Access Compliance Report

Public Rights-of-Way

Intersection ID: 9085	Main Street: EASTWAY_DR	Cross Street: CURTISWOOD_DR	Location: NW
ADA ID: 94C091455C09	Ramp Type: Perp	Initial Pass/Fail: Fail	Overall Compliance: No
		Severity Score: 1.25

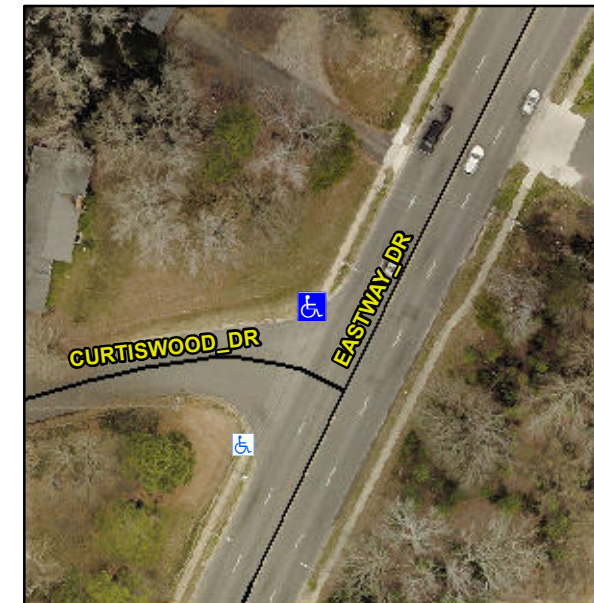
Not Found, R304.5.3

Compliance	Description	Data	Compliance	Description	Data
N/A	Ramp Length (in)	28.0	Yes	Ramp Slope (%)	6.9
Yes	Ramp Width (in)	52.0	No	Ramp XSlope (%)	2.6
N/A	Flare Type LT	N/A	N/A	Flare Type RT	N/A
N/A	Flare Slope LT (%)	N/A	N/A	Flare Slope RT (%)	N/A
N/A	Flare Traversable LT?	N/A	N/A	Flare Traversable RT?	N/A
N/A	Landing Length (in)	N/A	N/A	DWS Provided?	N/A
N/A	Landing Width (in)	N/A	N/A	DWS Contrast?	N/A
N/A	Landing Slope (%)	N/A	N/A	DWS Length (in)	N/A
N/A	Landing X Slope (%)	N/A	N/A	DWS Full Width?	N/A
N/A	Landing Curb? (Y/N)	N/A	N/A	DWS Offset (in)	N/A
N/A	Shared Landing?	N/A			
N/A	Gutter Ponding?	N/A	N/A	Gutter Slope (%)	N/A
N/A	Gutter Lip Ht (in)	0.5	N/A	Gutter X Slope (%)	N/A
N/A	Painted X Walk1?	No	N/A	Painted X Walk2?	N/A
	X Walk 1 Direction	To SW		X Walk 2 Direction	N/A
N/A	X Walk 1 Width (in)	N/A	N/A	X Walk 2 Width (in)	N/A
	X Walk 1 Slope (%)	2.3		X Walk 2 Slope (%)	N/A
	X Walk 1 X Slope (%)	1.2		X Walk 2 X Slope (%)	N/A

Remove & Replace Entire Ramp.
